Design Review & Historic Preservation Board
Agenda
November 11, 2021

Design Review and Historic Preservation Board
Minutes
October 28, 2021

DESIGN REVIEW AND HISTORIC PRESERVATION BOARD REFERRAL OF APPLICATION

APPENDUM #1 - CHANGE WINDOWS & DOORS ON SHTS. AD-1
& AD-2 FROM ORIGINAL CONST. DOCUMENTS

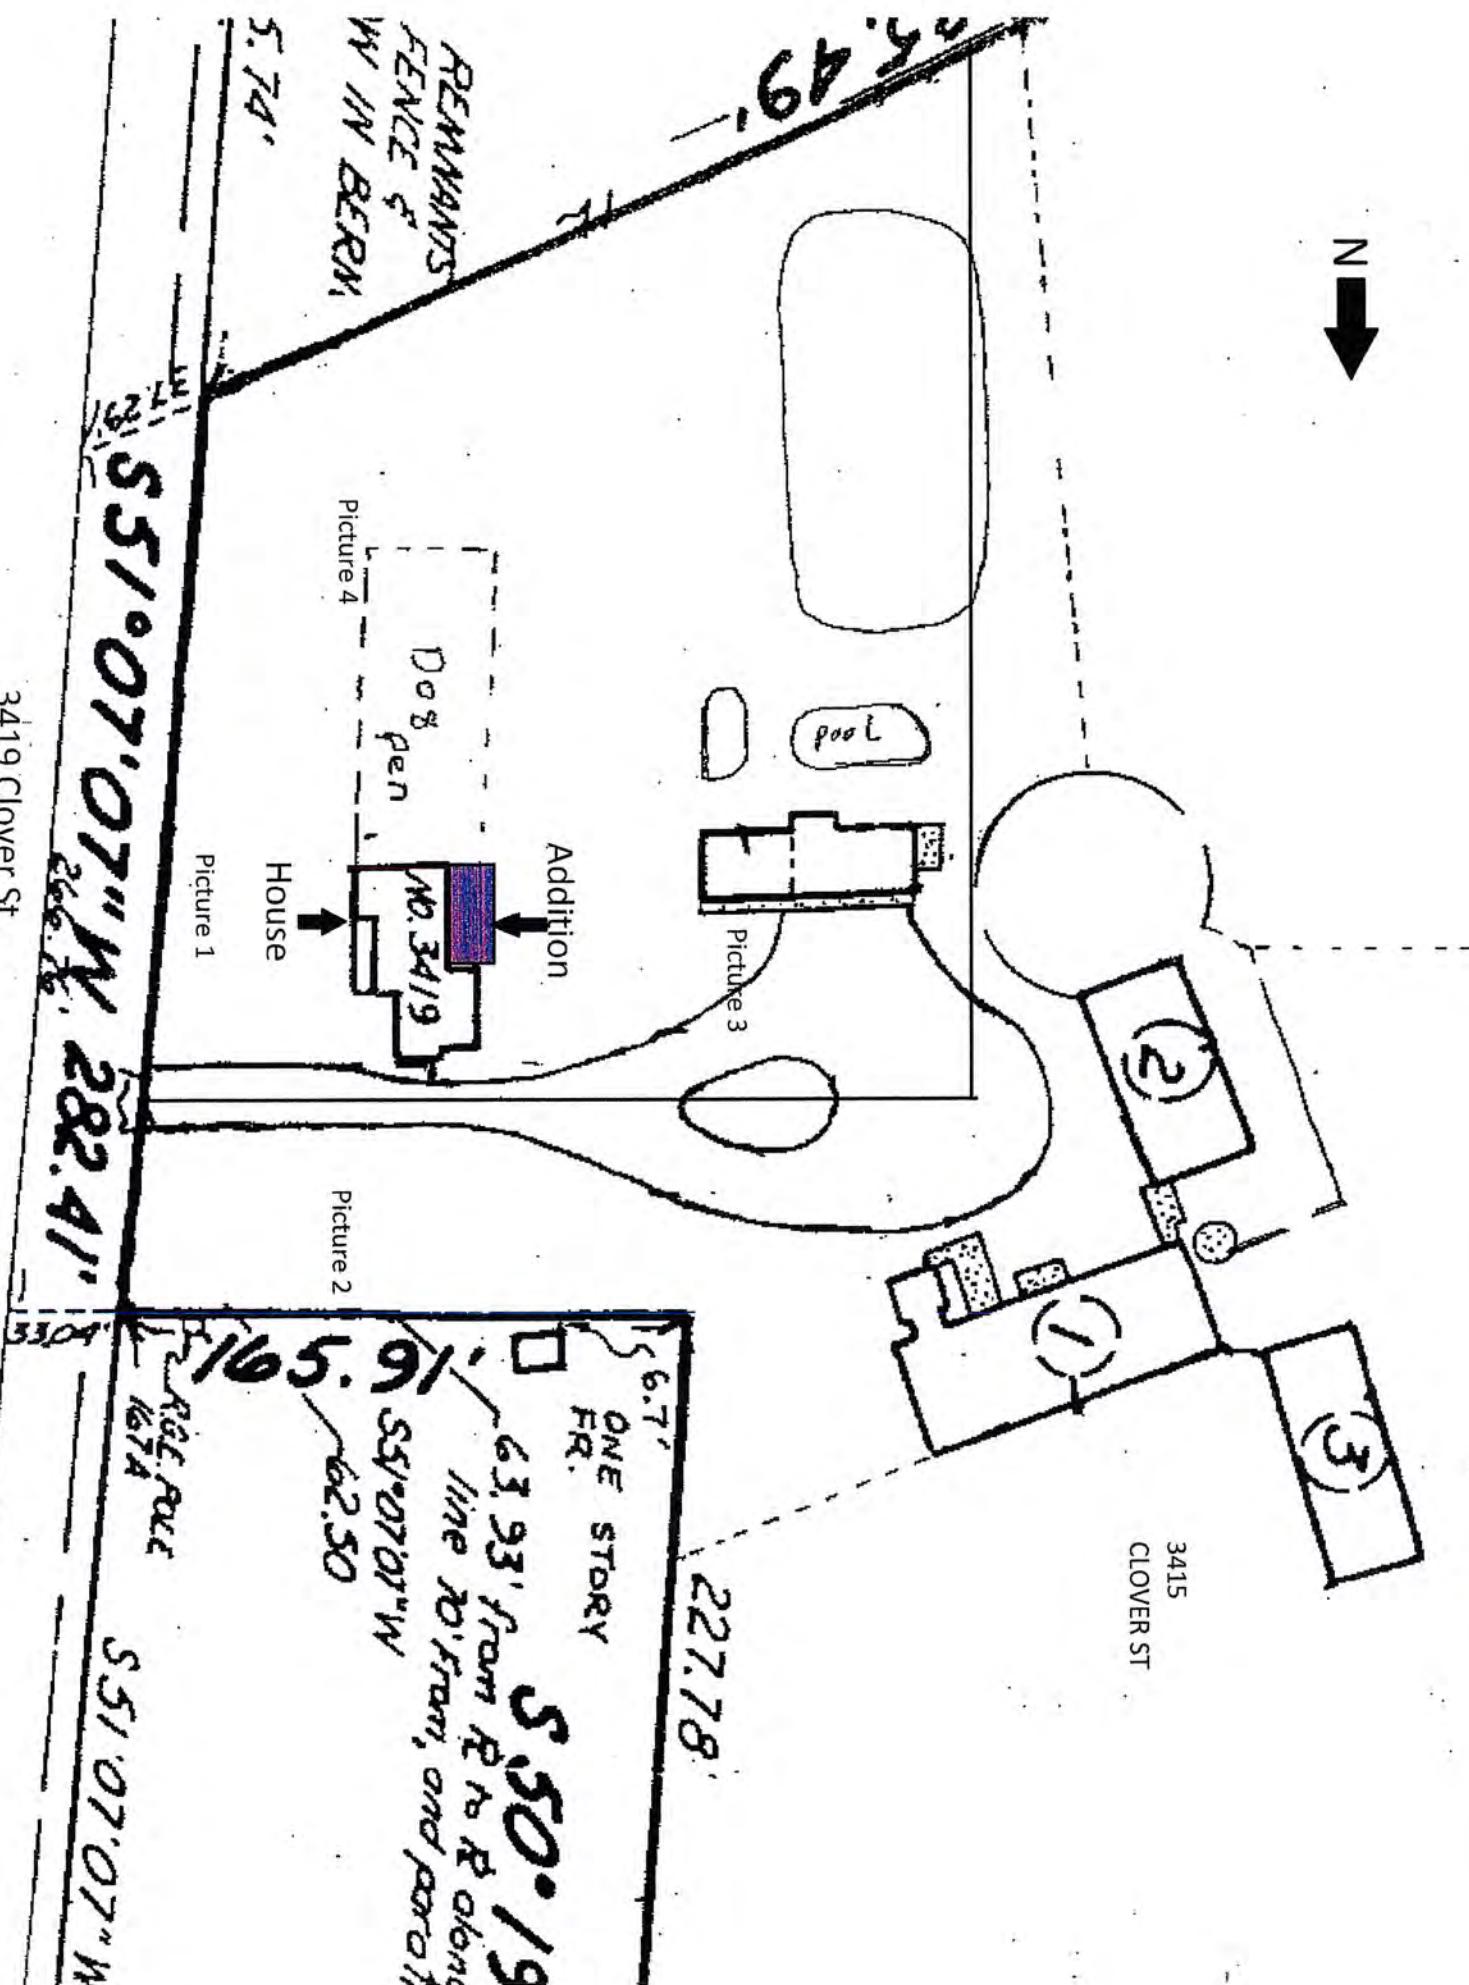
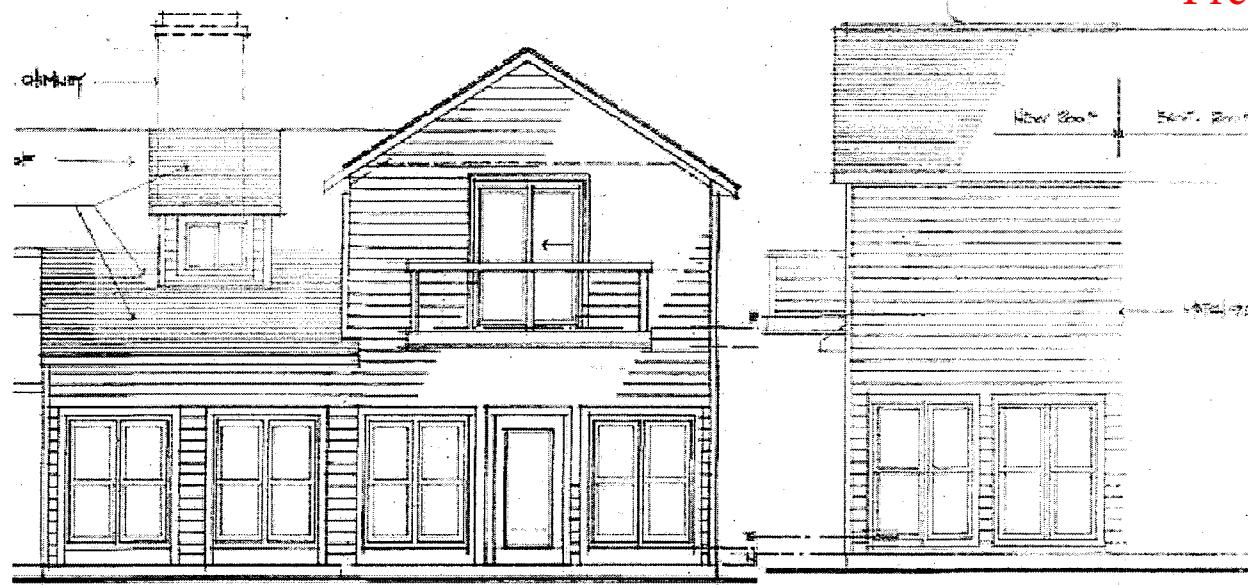
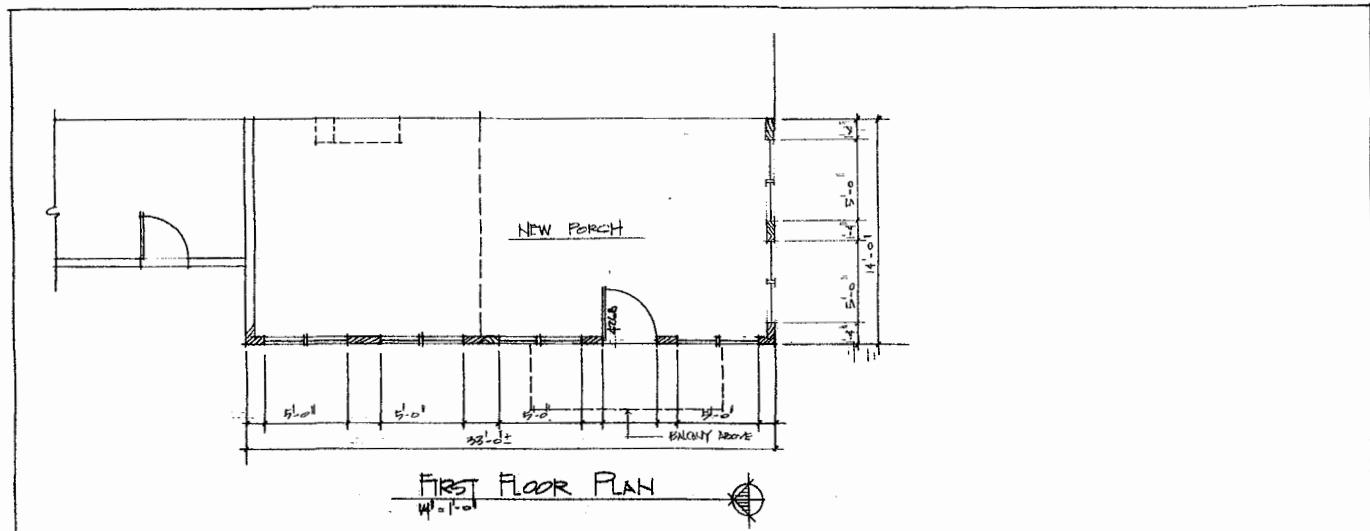
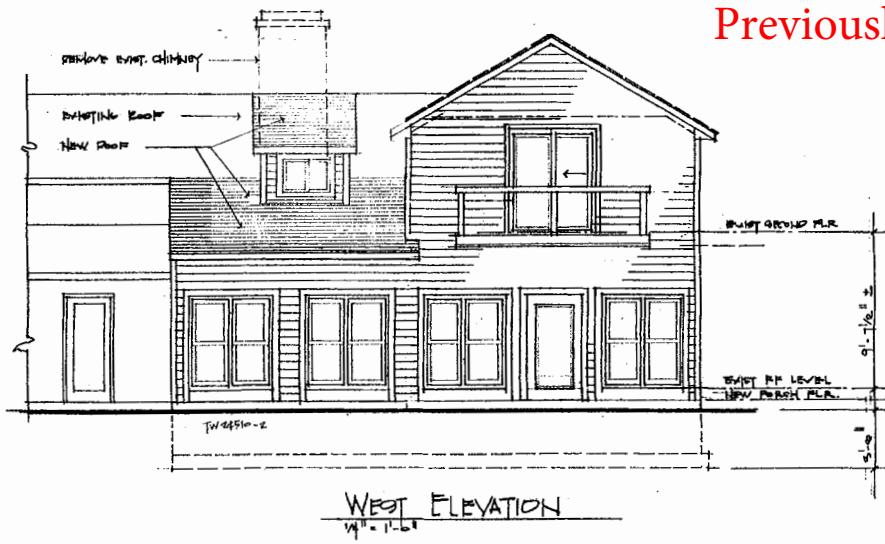
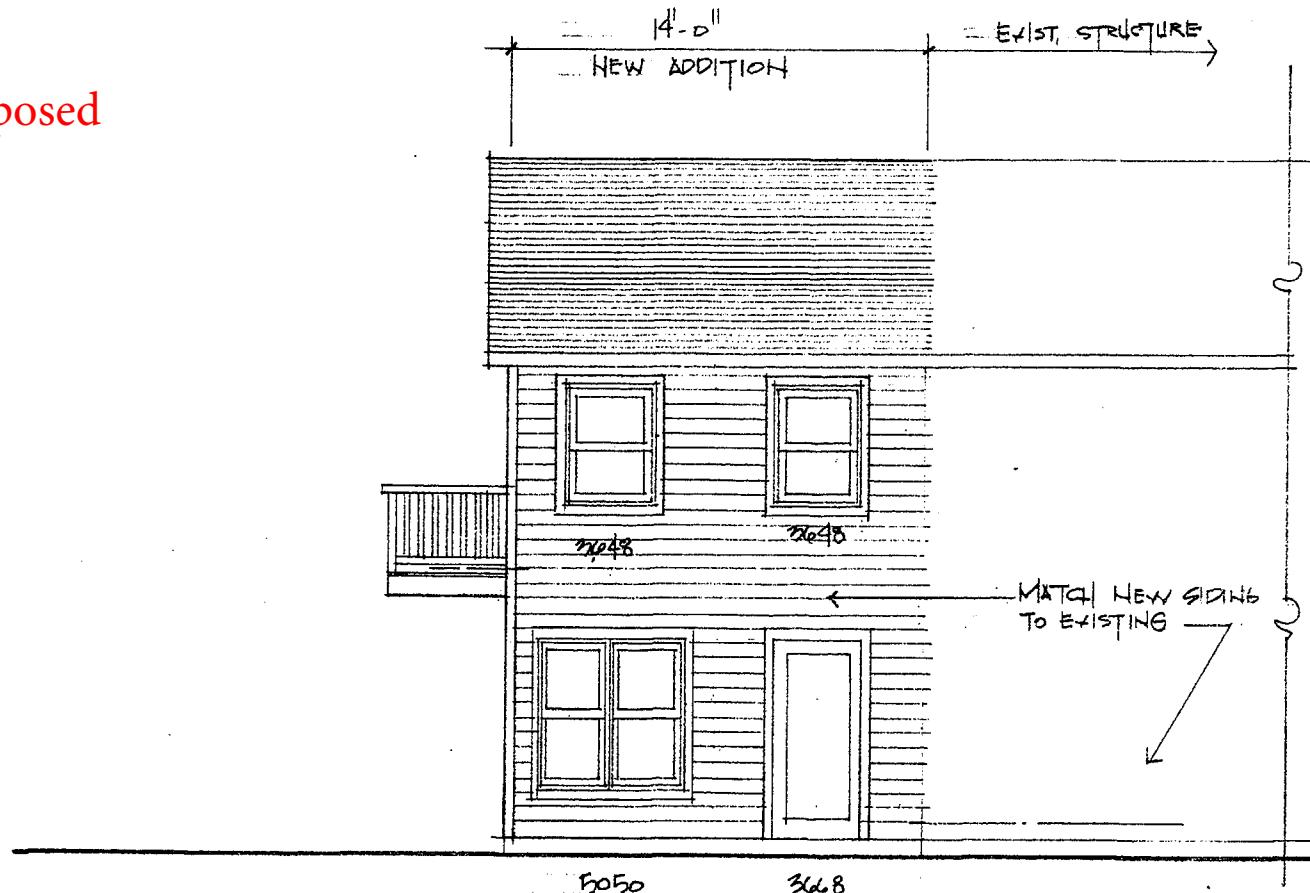
I will like to make the following changes to my home addition plans that was approved back in May 2021

- 1: Remove 1 60x60 window on the First Floor south side
- 2: Replace window on south side with a person door and a dog door
- 3: Remove French door on Second Floor west side and Replace with a 36x80 inch door
- 4: Install 2 36x48 windows to the west side second floor
- 5: Install 2 36x48 windows to the south side second floor

the 36 x 48 windows being added to the second floor will be the same size as windows already on the that side of house

will like to make changes from below picture to above
